## Product Change Notice (PCN)

**Subject:** Site addition of package assembly and final test

PCN# : [PC-SOC-A005A/E]

Outline Drawing for additional product:  
RZ/T1-M (112BGA)

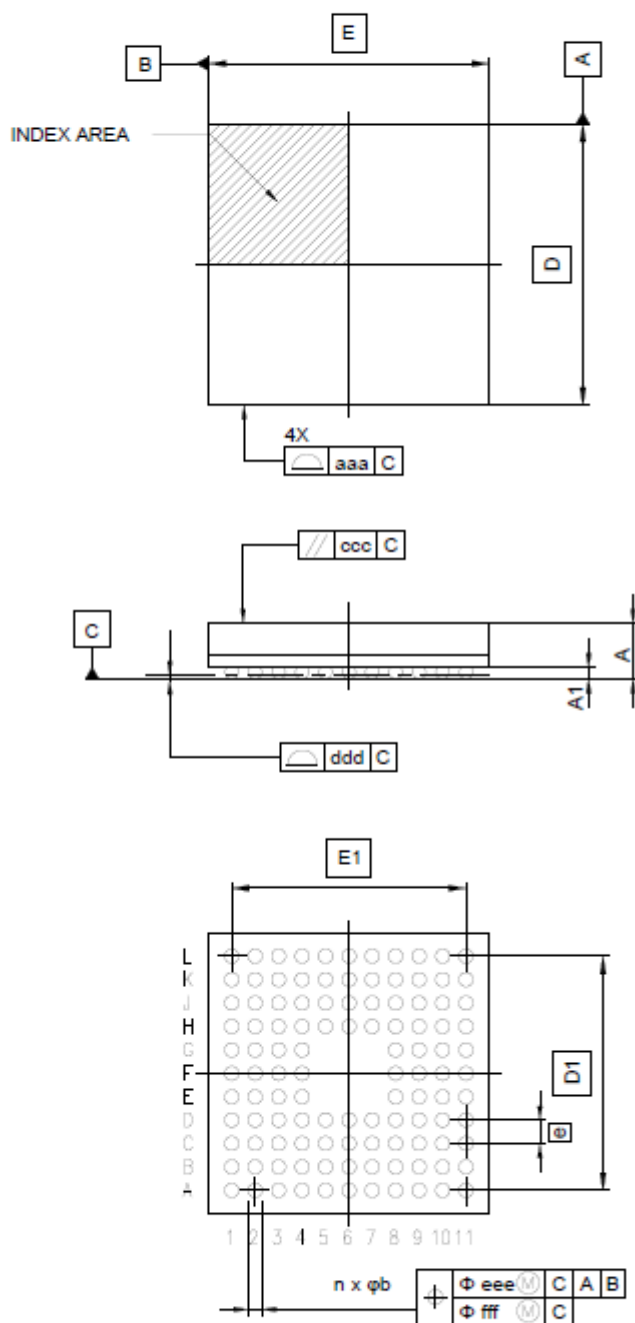
For RZ/T1-M, package size (min.) is changed from 5.80mm to 5.85mm and (max.) is changed from 6.20mm to 6.15mm, and package total thickness (max.) is changed from 1.70mm to 1.35mm, because of assembly site change. For EC-1, package size (min.) is changed from 11.92mm to 11.85mm and (max.) is changed from 12.08mm to 12.15mm, and package total thickness (max.) is changed from 1.60mm to 1.50mm. No impact on the fit, function, quality, and reliability.

Current product					Additional product				
RZ/T1-M (112BGA)									
	Symbol	Dimension in Millimeters				Symbol	Dimension in Millimeters		
		Min.	Nom.	Max.			Min.	Nom.	Max.
Package size	D	5.80	6.00	6.20	Package size	D	<b>5.85</b>	6.00	<b>6.15</b>
Package size	E	5.80	6.00	6.20	Package size	E	<b>5.85</b>	6.00	<b>6.15</b>
Total thickness	A	-	-	1.70	Total thickness	A	-	-	<b>1.35</b>
Stand off	A1	0.20	0.25	0.30	Stand off	A1	0.20	0.25	0.30
Ball pitch	e	-	0.50	-	Ball pitch	e	-	0.50	-
Ball width	b	0.25	0.30	0.35	Ball width	b	0.25	0.30	0.35
Ball offset (Package)	x1	-	-	0.20	Ball offset (Package)	x1	-	-	<b>0.15</b>
Ball offset (Ball)	x2	-	-	0.05	Ball offset (Ball)	x2	-	-	0.05
Coplanarity	y	-	-	0.08	Coplanarity	y	-	-	0.08
Mold parallelism	y1	-	-	0.20	Mold parallelism	y1	-	-	0.20

Reference Symbol	Dimension in Millimeters		
	Min.	Nom.	Max.
D	—	6.00	—
E	—	6.00	—
D1	—	5.00	—
E1	—	5.00	—
A	—	—	1.35
A1	0.20	—	—
b	0.25	0.30	0.35
e	—	0.50	—
aaa	—	—	0.15
ccc	—	—	0.20
ddd	—	—	0.08
eee	—	—	0.15
fff	—	—	0.05
n	—	112	—

JEITA Package code	RENESAS code	MASS(TYP.)[g]
P-LFBGA196-12x12-0.80	PLBG0196GB-A	0.43

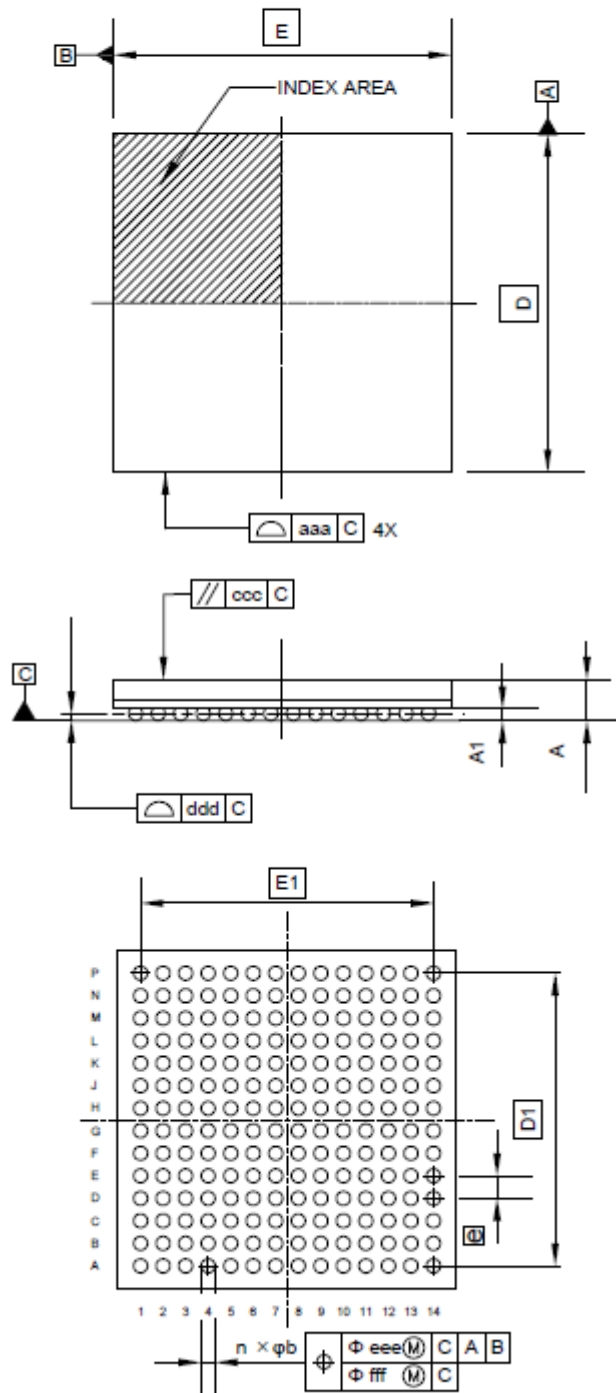
Current product					Additional product				
EC-1 (196BGA)									
	Symbol	Dimension in Millimeters				Symbol	Dimension in Millimeters		
		Min.	Nom.	Max.			Min.	Nom.	Max.
Package size	D	11.92	12.00	12.08	Package size	D	<b>11.85</b>	12.00	<b>12.15</b>
Package size	E	11.92	12.00	12.08	Package size	E	<b>11.85</b>	12.00	<b>12.15</b>
Total thickness	A	-	-	1.60	Total thickness	A	-	-	<b>1.50</b>
Stand off	A1	0.35	0.40	0.45	Stand off	A1	<b>0.36</b>	<b>0.41</b>	<b>0.46</b>
Ball pitch	e	-	0.80	-	Ball pitch	e	-	0.80	-
Ball width	b	0.45	0.50	0.55	Ball width	b	0.45	0.50	0.55
Ball offset (Package)	x1	-	-	0.15	Ball offset (Package)	x1	-	-	0.15
Ball offset (Ball)	x2	-	-	0.08	Ball offset (Ball)	x2	-	-	0.08
Coplanarity	y	-	-	0.10	Coplanarity	y	-	-	0.10
Mold parallelism	y1	-	-	0.20	Mold parallelism	y1	-	-	0.20

Reference Symbol	Dimension in Millimeters		
	Min.	Nom.	Max.
$D$	—	12.00	—
$E$	—	12.00	—
$D1$	—	10.40	—
$E1$	—	10.40	—
A	—	—	1.50
A1	0.36	—	—
b	0.45	0.50	0.55
$e$	—	0.80	—
aaa	—	—	0.10
ccc	—	—	0.20
ddd	—	—	0.10
eee	—	—	0.15
fff	—	—	0.08
n	—	196	—
